DOCUMENT 009214 – INTERIORS PACKAGE ADDENDA – NO. 1

- A. Project Name: St. Patrick Catholic Church.
- B. Construction Manager: Kingery Construction.
- C. Architect: Clark Architects Collaborative 3.
- D. Architect Project Number: 11008.
- E. Date of Addendum: 11-12-14

Addendum 01 - Int. Package
11-12-14
AAD-1.0

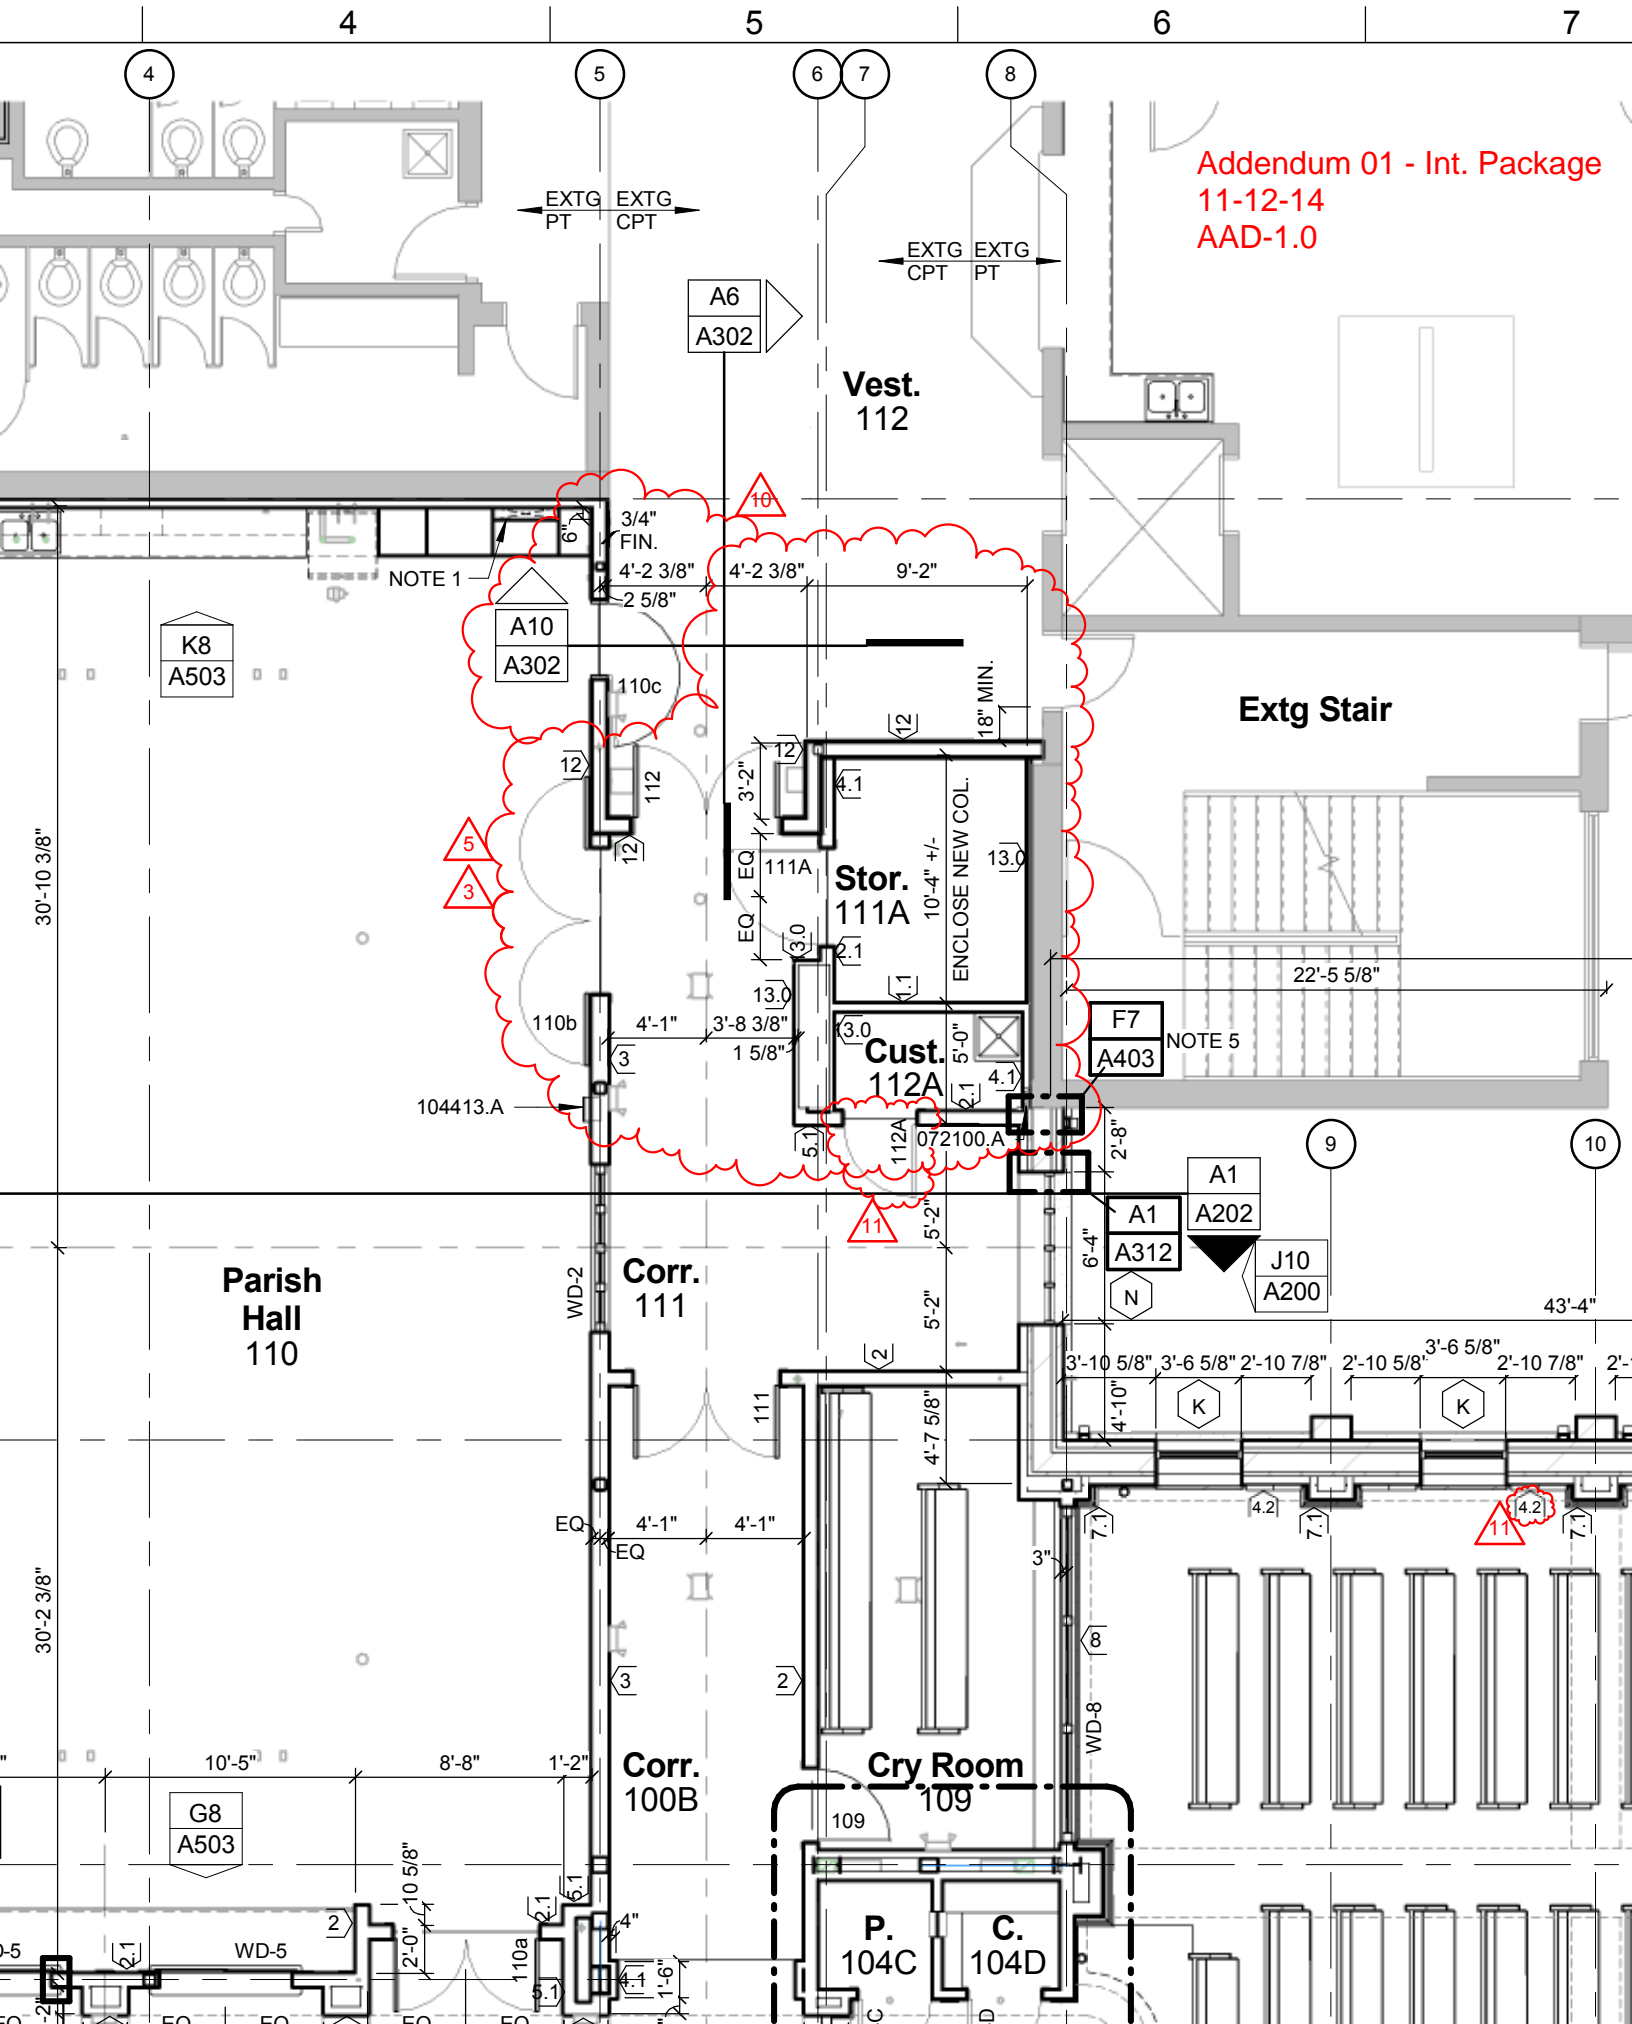
- A. Sheet A101 – First Floor Plan (not reissued).
 - 1. Furred out walls along the exterior wall perimeter of the Nave and Sanctuary – next to the 2” polyisocyanurate board insulation - to be Wall Type 4.2 with 1-layer of gypsum wall board in lieu of Wall Type 7.1 with 2-layers of gypsum wall board.
 - 2. Door 112A to swing out of room Cust. 112A per RFI-20. Flip door swing to open towards the Hall. See attached Architectural Addendum Drawing (AAD)-1.0.

Addendum 01 - Int. Package
11-12-14
AAD-3.0

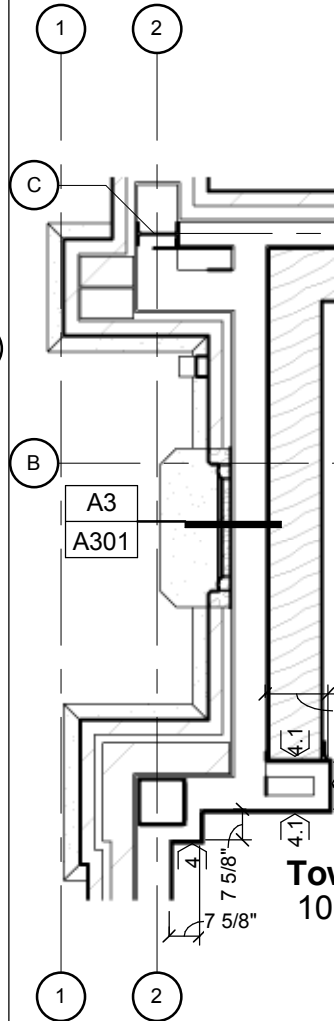
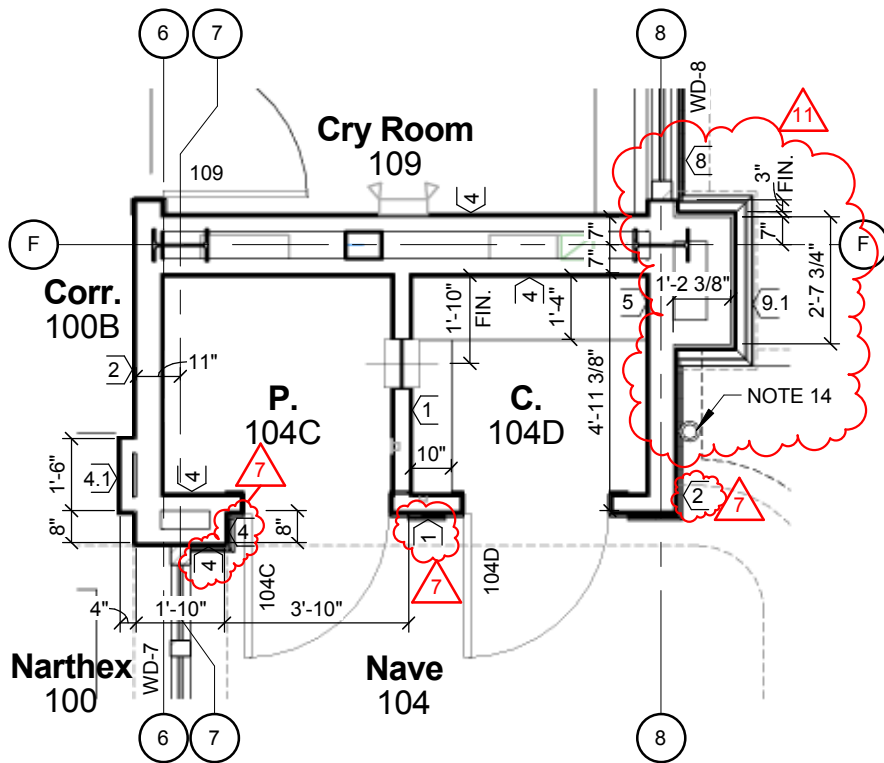
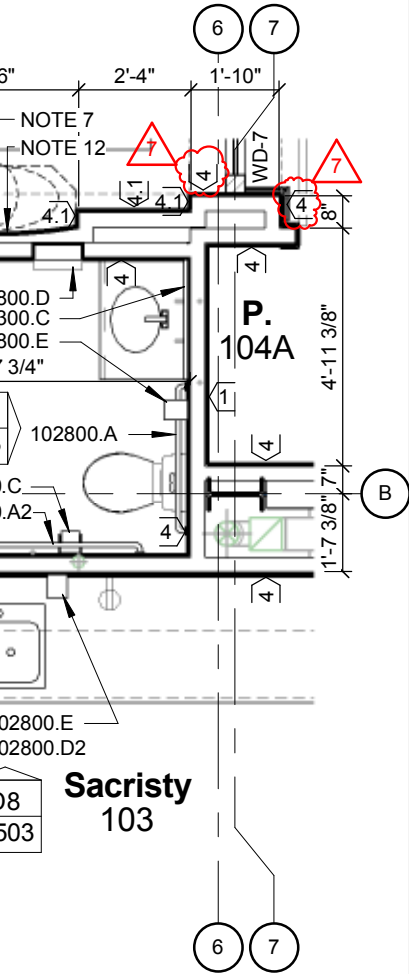
1. Enlarged Plan H3 - Revised framing dimensions for back main piers in Nave. Deletion of sister pier beside the back main piers. Note 14 callout of dedication candle. See attached AAD-3.0.

**Addendum 01 - Int. Package
11-12-14
AAD-5.0**

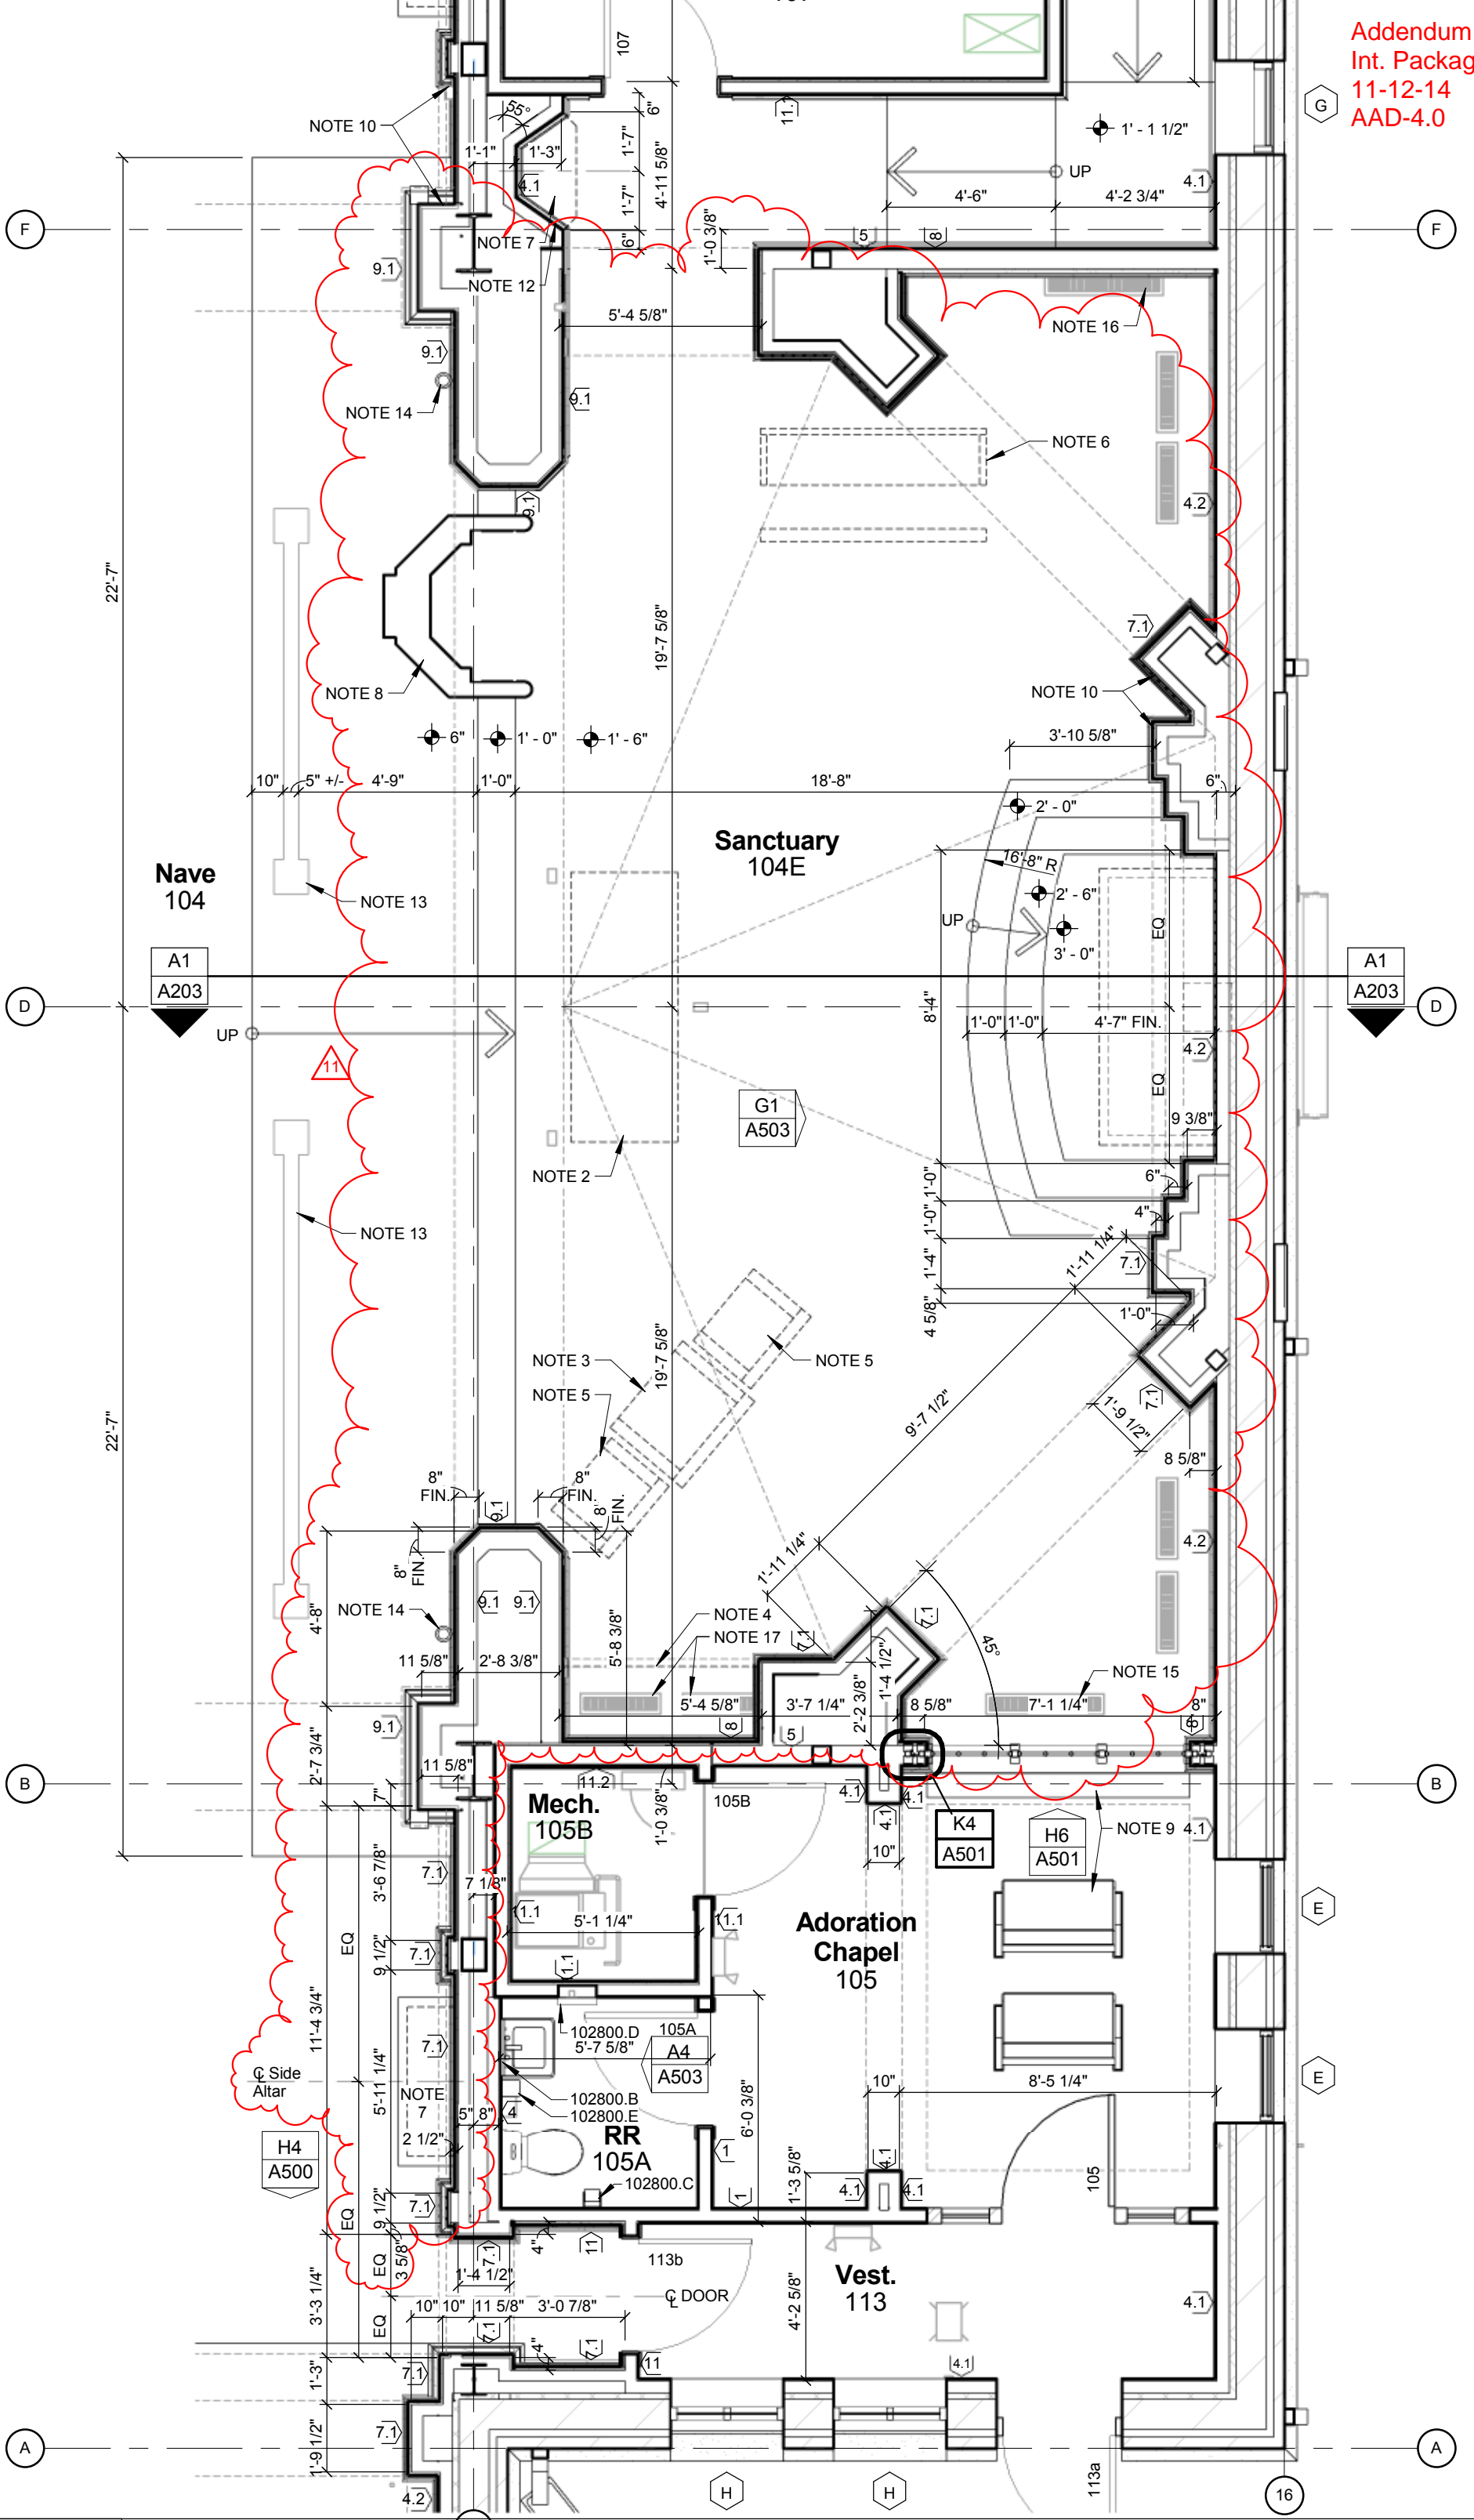
3. Sheet Specific Notes - Revised Note 5 and new Notes 14 – 17. See attached AAD-5.0.
- C. Sheet A110 – Door Schedule, Door Types, and Frame Types (not reissued).

NOTE 14: DEDICATION CANDLE - BY OWNER. GC TO PROVIDE REQUIRED BLOCKING. 11

NOTE 15: CENTER MECHANICAL FLOOR REGISTER ON OPENING.

NOTE 16: CENTER MECHANICAL FLOOR REGISTER BETWEEN ADJACENT WALLS.

NOTE 17: COORDINATE MECHANICAL FLOOR REGISTER LOCATION WITH STUD FRAMING.

Addendum 01 -
Int. Package
11-12-14
AAD-7.0

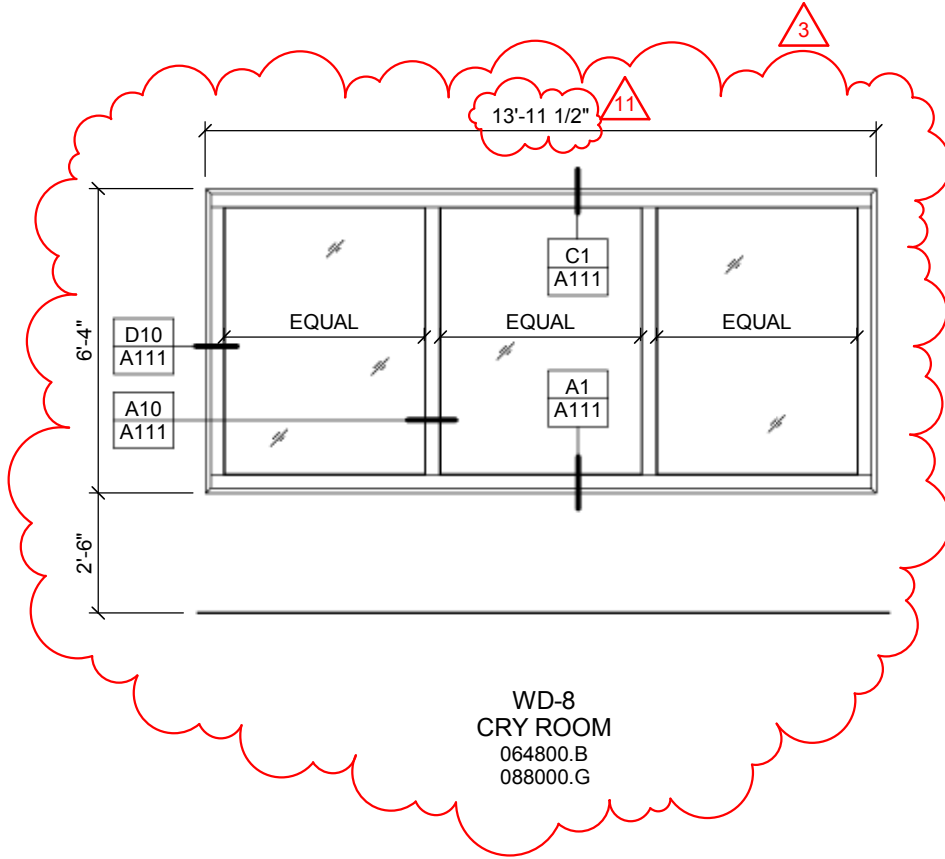
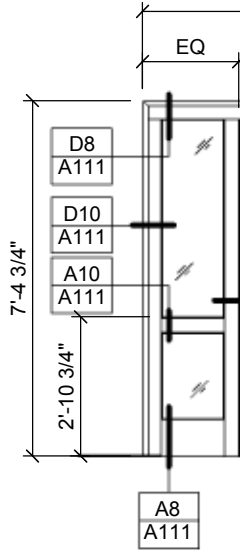
2. Revised Door Schedule - Door Type for 100a to be WD-D. Door Type for 100b and 100c to be WD-C.
 3. Revised Wood Frame Types – Length of Frame Type WD-8 to be 13'-11 ½". See attached AAD-7.0.
